*Revised Down-Gradient Groundwater Assessment Work Plan*  
*Fountain-Vine Plaza, 1253 Vine Street, Los Angeles, California 90028*  
*January 21, 2014*

**Re: Further Revised Down-Gradient Groundwater Assessment Work Plan, Fountain-Vine Plaza, 1253 N. Vine Street, Los Angeles, California 90028, LARWQCB SLIC No. 1196, Global ID SL0603734628**

**SUBJECT: RESPONSE TO A REQUEST FOR REVIEW OF THE FURTHER REVISED  
WORK PLAN DATED ON FEBRUARY 12, 2014**

Regional Board staff have reviewed the report titled *Further Revised Down-Gradient Assessment Work Plan (Work Plan)*, dated February 12, 2014, in response to a request made during a meeting with you and your representatives on May 22, 2014. Please note that a response to the Work Plan had been provided on March 3, 2014 (attached). This letter replaces that letter. In response to your request for a further review, we have the following comments and revisions to the Work Plan:

**Figure 3: Proposed Monitoring Well Location Map**  
**Fountain-Vine Plaza**  
 1253 Vine Street  
 Los Angeles, California 90028

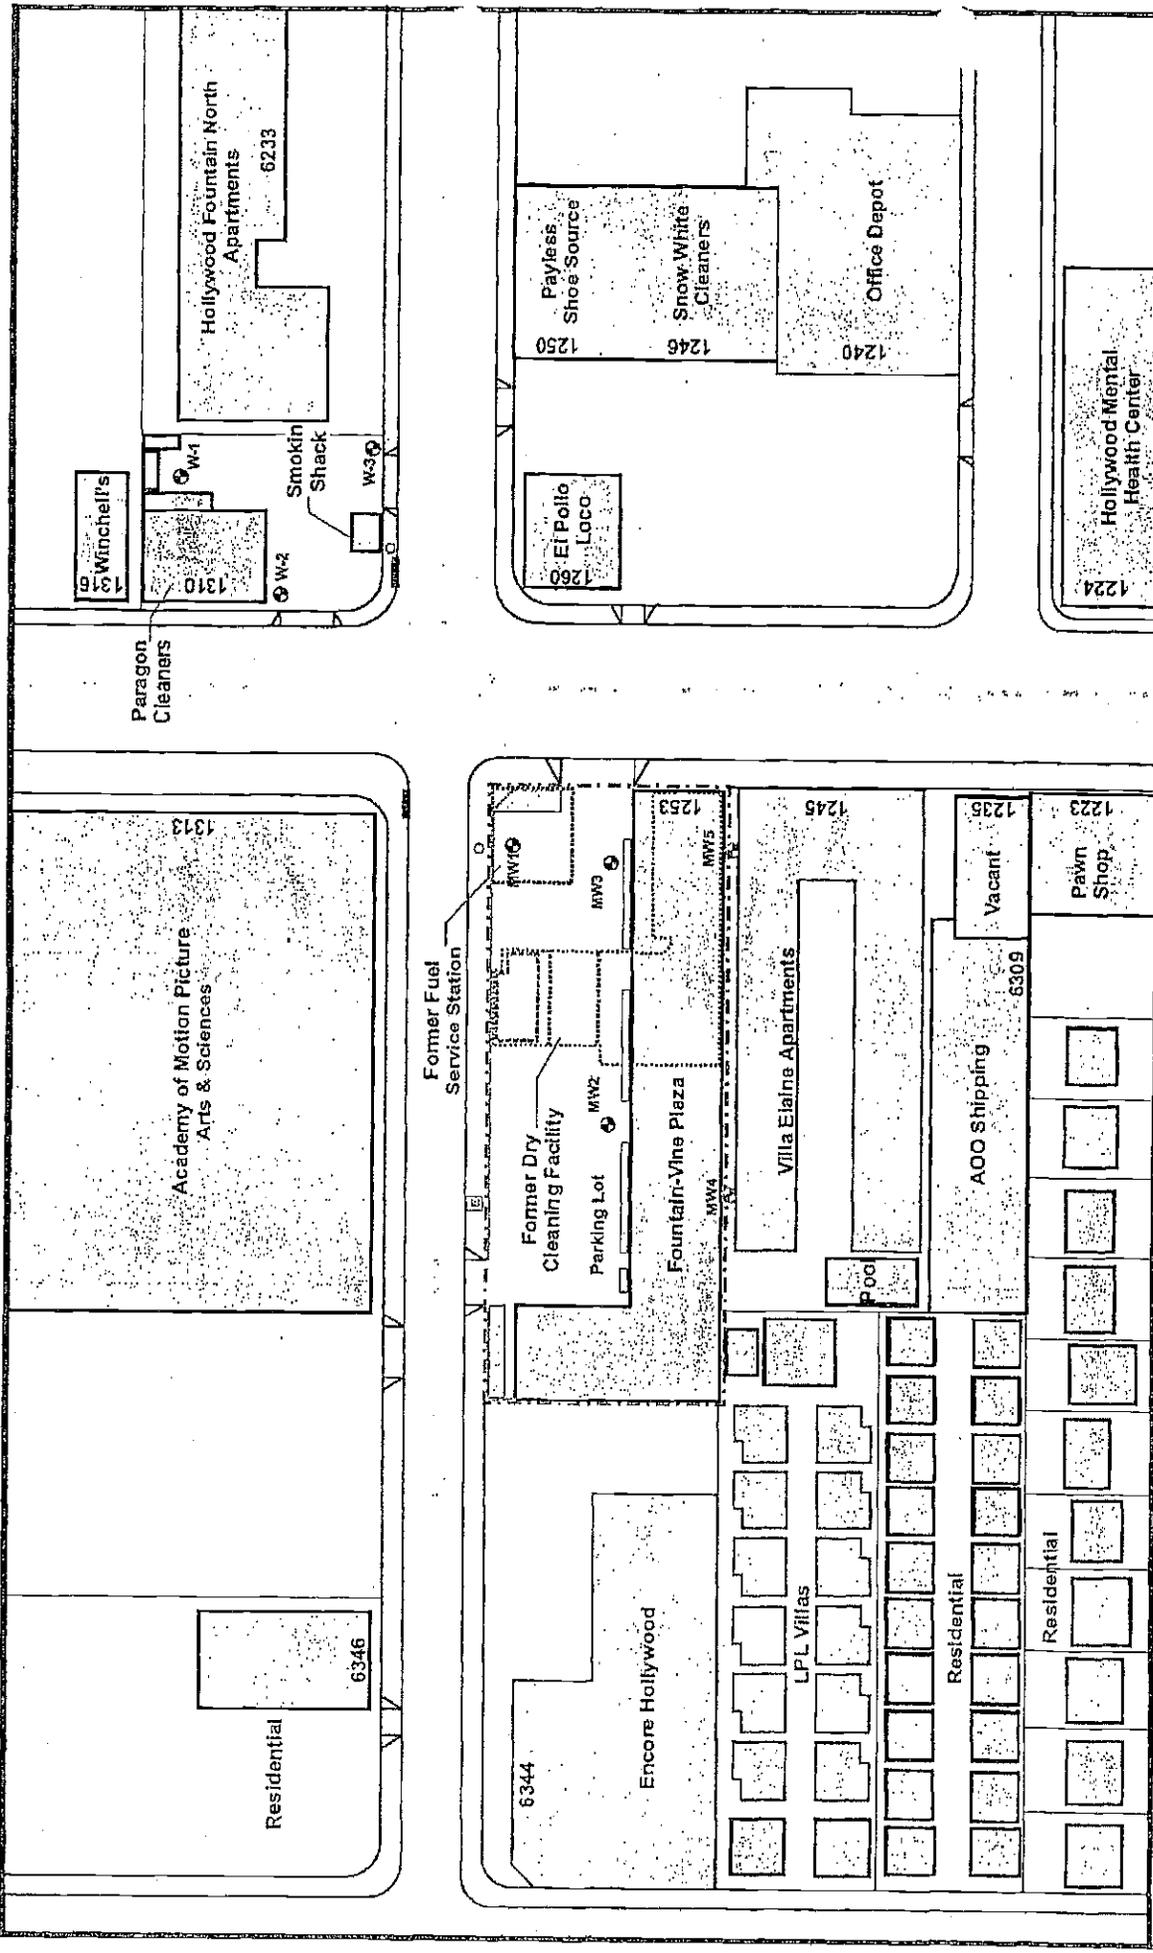
With these objectives in mind, two soil borings at the locations agreed to with LARWQCB staff (revised Figure 3) will be advanced off-site in the north alley/pathway located at the northern boundary of the Villa Elaine apartment complex.

- Advance two off-site, hollow-stem auger borings from grade to approximately 45 feet below ground surface (bgs) as shown on revised Figure 3. Soil samples will be collected from each of the borings at 5-foot intervals for lithologic evaluation and field screening of volatile organic compounds (VOCs) using a photo-ionization detector (PID) calibrated to a 100 parts per million (ppm) isobutylene standard. No soil samples will be submitted for laboratory analysis.

**Figure X: Proposed Monitoring Well Location Map**  
 Fountain-Vine Plaza  
 1253 Vine Street  
 Los Angeles, California 90028  
 DRAWN BY: LW/WRD DATE: January 2014 PROJECT: Fountain-Vine.p01  
 Ami Adini & Associates, Inc.

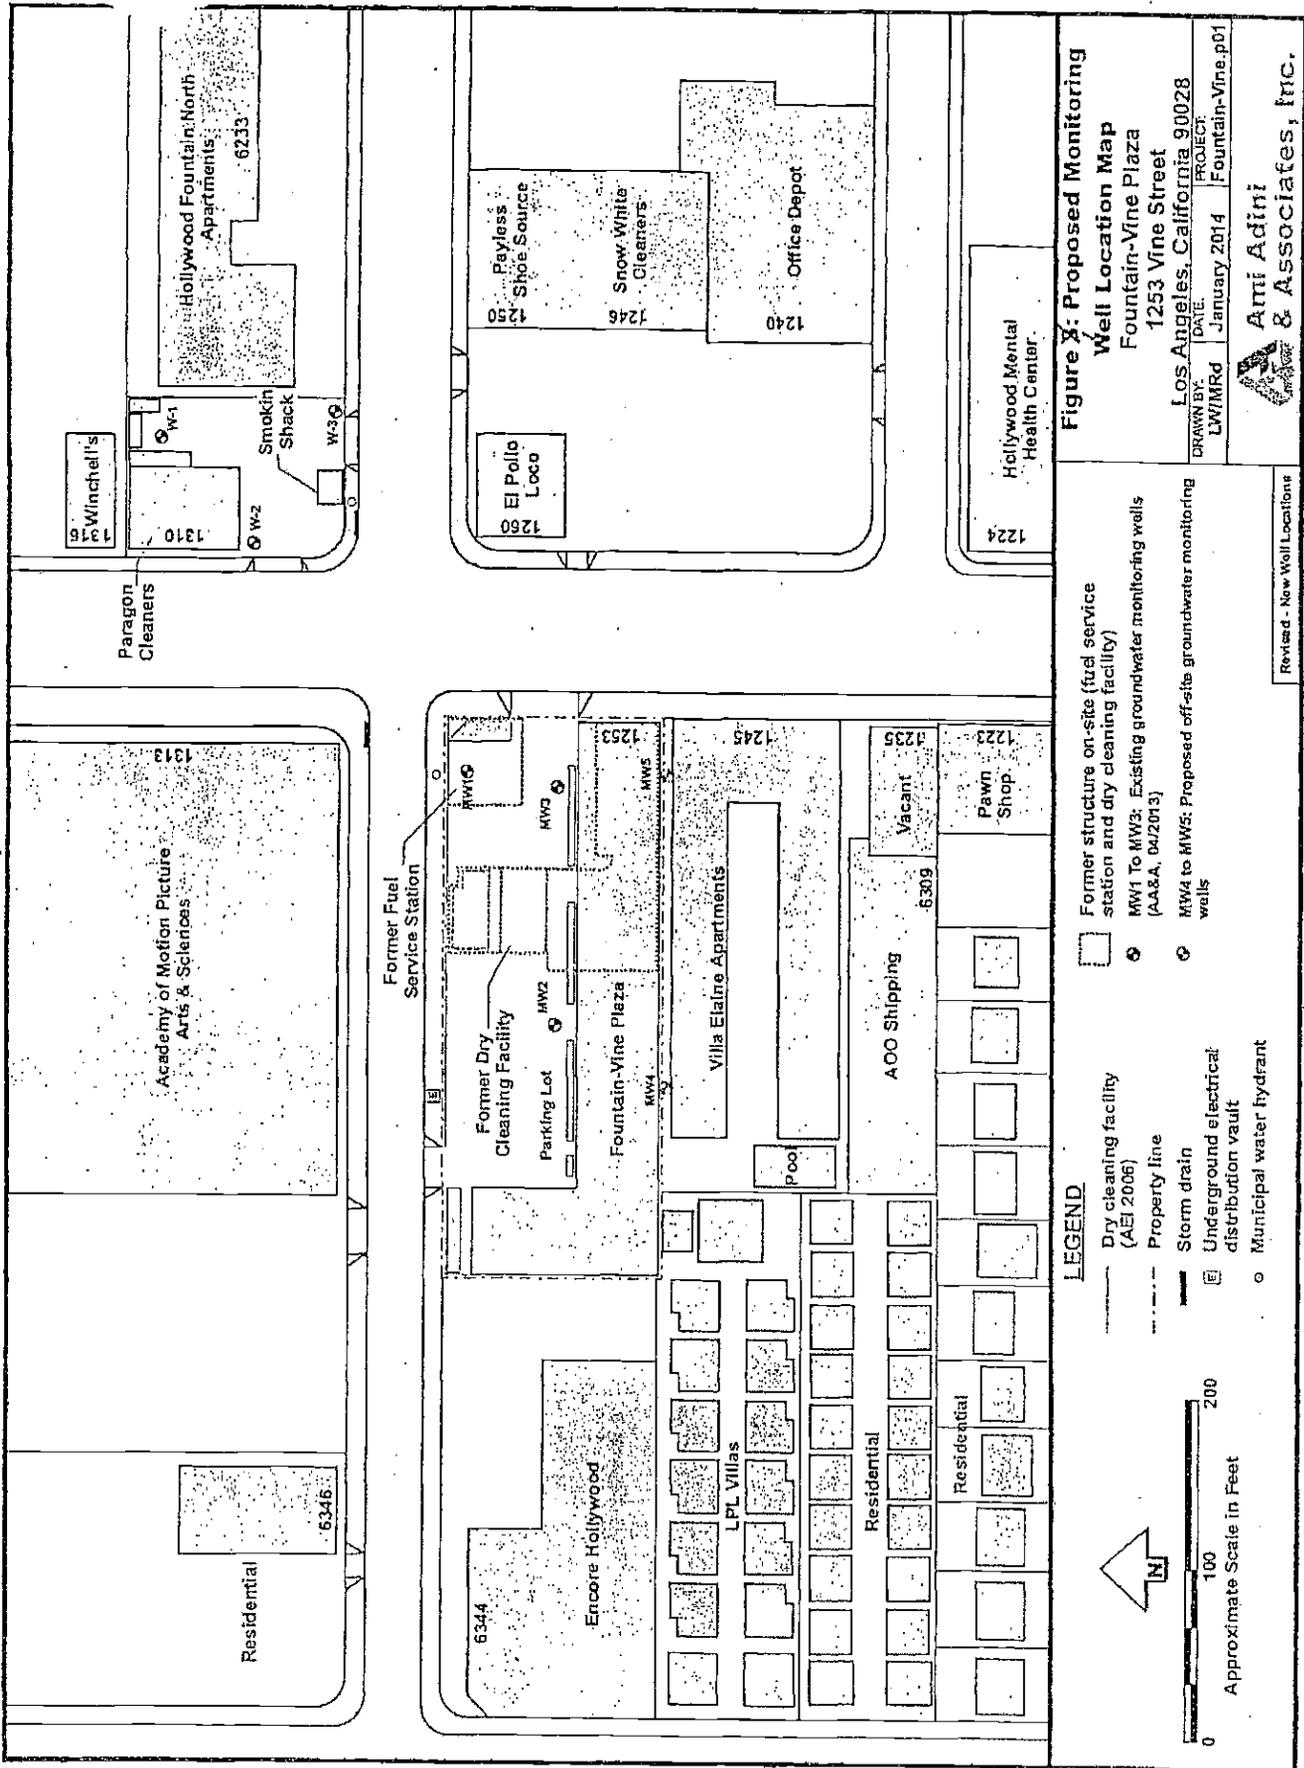
The work plan proposes the installation of two (2) groundwater monitoring wells (MW-4 and MW-5) located within the Villa Elaine apartment complex, immediately south of the site (Figure 1). Groundwater will then be sampled from eight (8) groundwater monitoring wells located at the site, at the Villa Elaine apartments, and at Paragon Cleaners (located northeast of the site). Groundwater samples will be analyzed for volatile organic compounds (VOCs) and total petroleum hydrocarbons – gasoline range (TPHg).

On January 28, 2014, Mr. Ami Adini informed the Regional Board that the work plan may be further revised based on structural information that is being provided to him by Ms. Patten. Since the Villa Elaine Apartments is a historical site, there are some restrictions to drilling. If the location of the groundwater monitoring wells, or the number of the groundwater monitoring wells are modified beyond what has been indicated in the work plan, then you shall inform the Regional Board and get written approval from the Regional Board before you begin installing the groundwater monitoring wells.

Based on information submitted, and on the information in the case file, we concur with the proposed work plan. A technical report shall be submitted electronically to the Regional Board documenting the installation of the groundwater monitoring wells by **April 15, 2014**. A groundwater monitoring report shall be submitted with the technical report and shall include an analysis of the data obtained from the eight groundwater monitoring wells.

**Figure 3: Proposed Monitoring Well Location Map**  
**Fountain-Vine Plaza**  
 1253 Vine Street  
 Los Angeles, California 90028

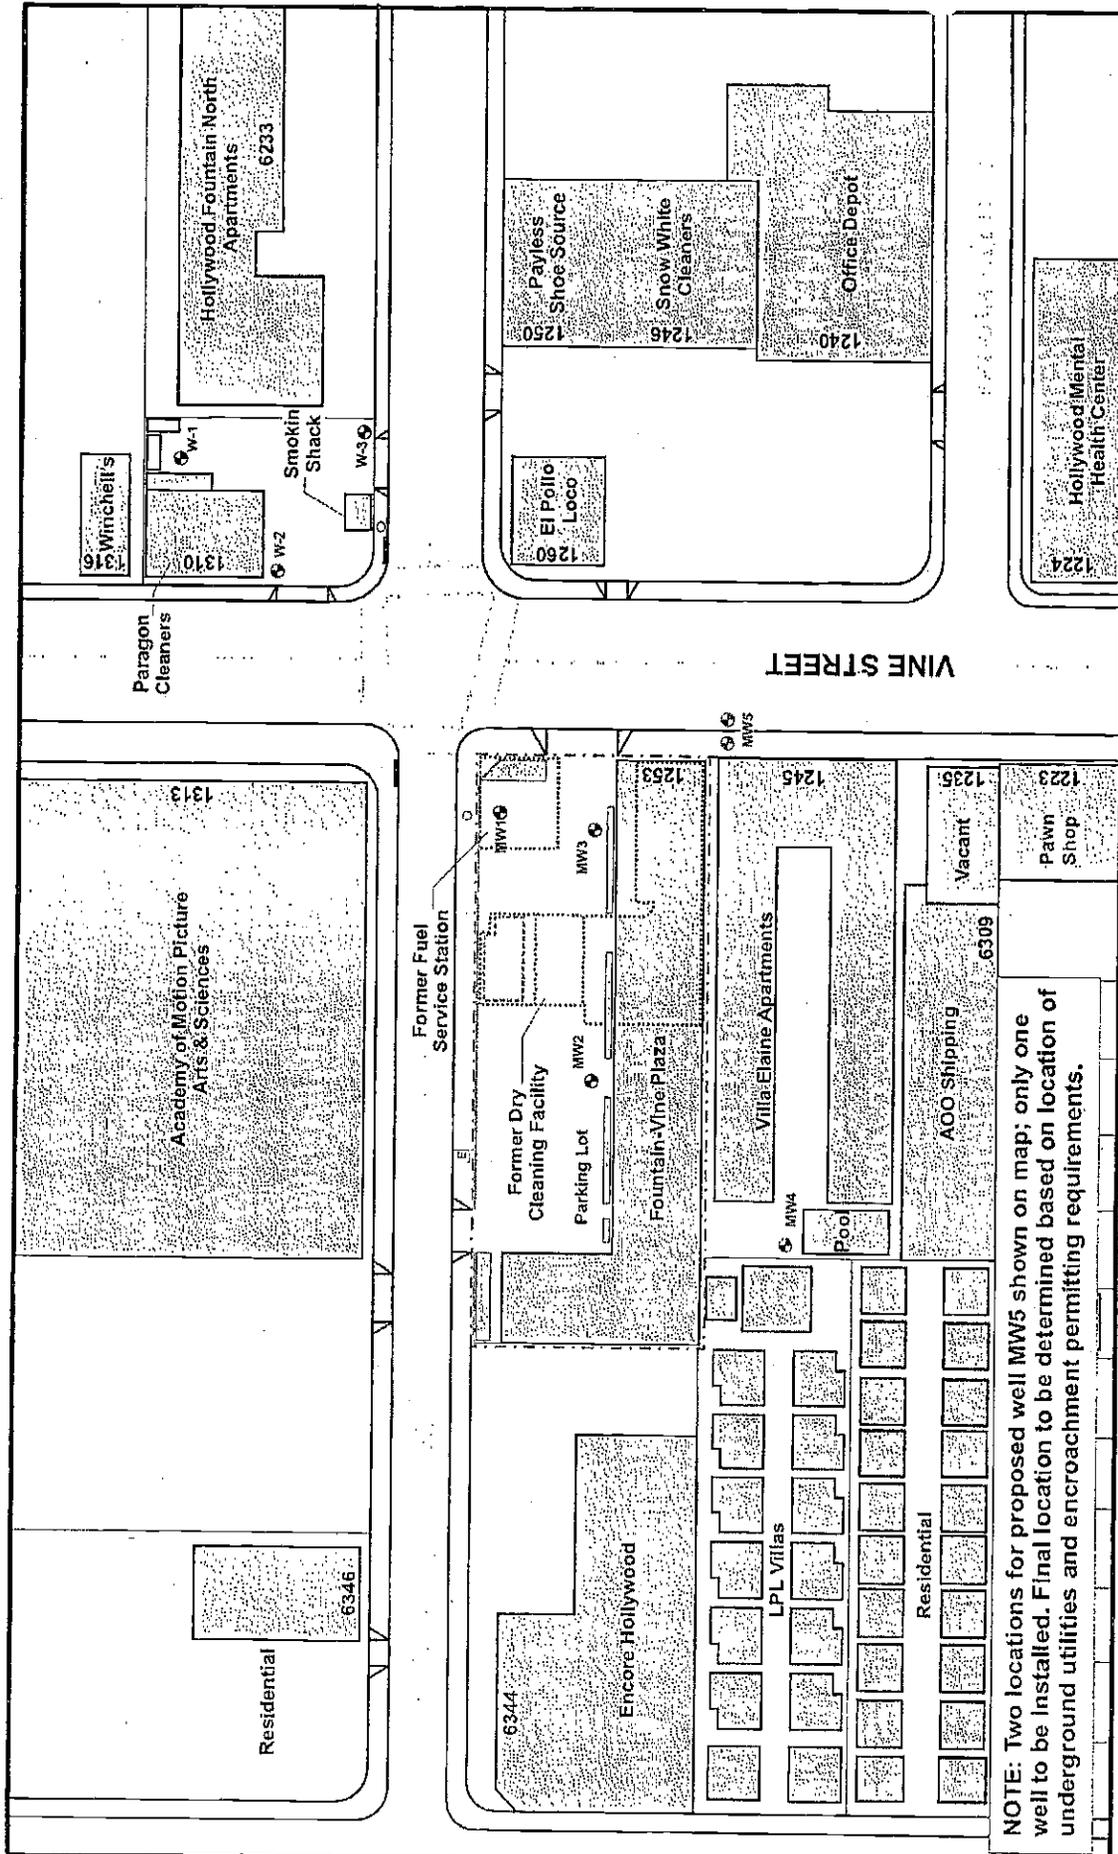
- Advance two off-site, hollow-stem auger borings from grade to approximately 45 feet below ground surface (bgs) as shown on revised Figure 3. Well MW4 is proposed to be installed in the vicinity of the abandoned swimming pool at the Villa Elaine Apartments at a minimum distance of 20 feet from the exterior wall of the building. Well MW5 is proposed to be installed in the sidewalk or parking lane near the northeast corner of the Villa Elaine Apartments at a minimum distance of 4 feet from the exterior wall of the building. The final location of well MW5 will be determined based on the locations of subsurface utilities and encroachment permitting requirements.

**NOTE:** Two locations for proposed well MW5 shown on map; only one well to be installed. Final location to be determined based on location of underground utilities and encroachment permitting requirements.

**Figure X: Proposed Monitoring Well Location Map**

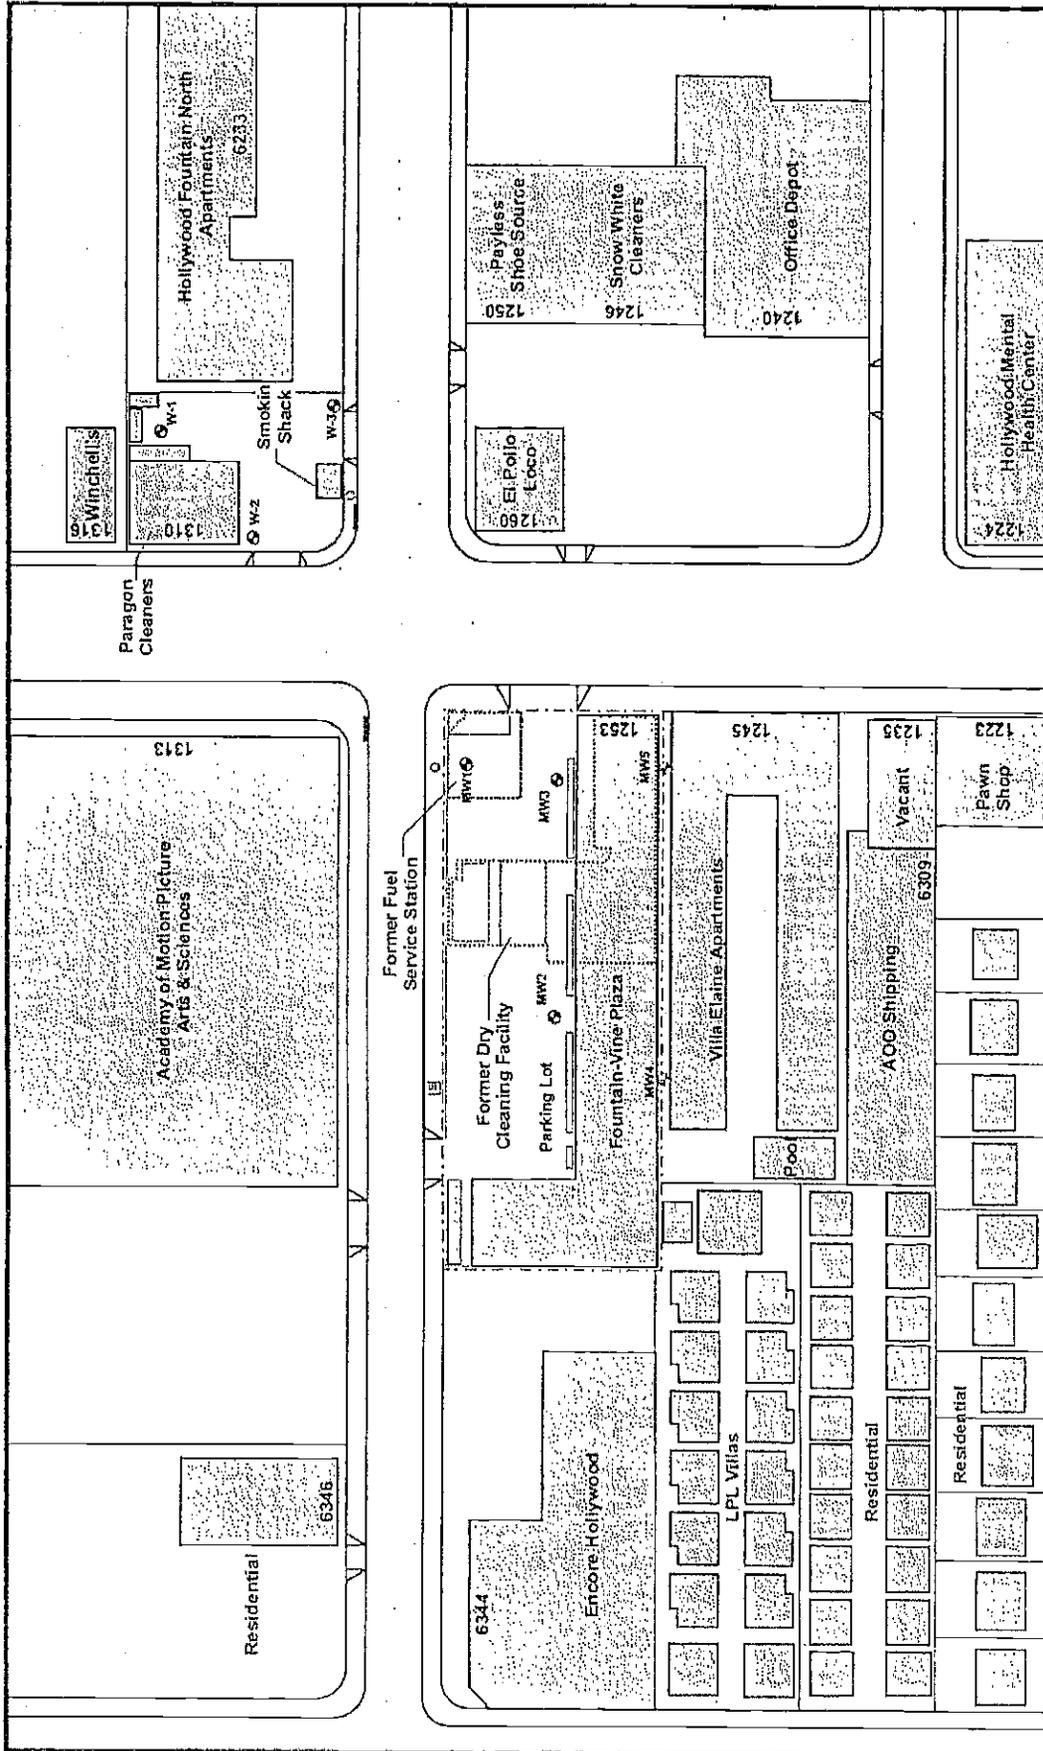
The work plan proposes the installation of two (2) groundwater monitoring wells (MW-4 and MW-5) located within the Villa Elaine apartment complex, immediately south of the site (Figure 1). Groundwater will then be sampled from eight (8) groundwater monitoring wells located at the site, at the Villa Elaine apartments, and at Paragon Cleaners (located northeast of the site). Groundwater samples will be analyzed for volatile organic compounds (VOCs) and total petroleum hydrocarbons – gasoline range (TPHg).

On January 28, 2014, Mr. Ami Adini informed the Regional Board that the work plan may be further revised based on structural information that is being provided to him by Ms. Patten. Since the Villa Elaine Apartments is a historical site, there are some restrictions to drilling. If the location of the groundwater monitoring wells, or the number of the groundwater monitoring wells are modified beyond what has been indicated in the work plan, then you shall inform the Regional Board and get written approval from the Regional Board before you begin installing the groundwater monitoring wells.

Based on information submitted, and on the information in the case file, we concur with the proposed work plan. A technical report shall be submitted electronically to the Regional Board documenting the installation of the groundwater monitoring wells by **April 15, 2014**. A groundwater monitoring report shall be submitted with the technical report and shall include an analysis of the data obtained from the eight groundwater monitoring wells.
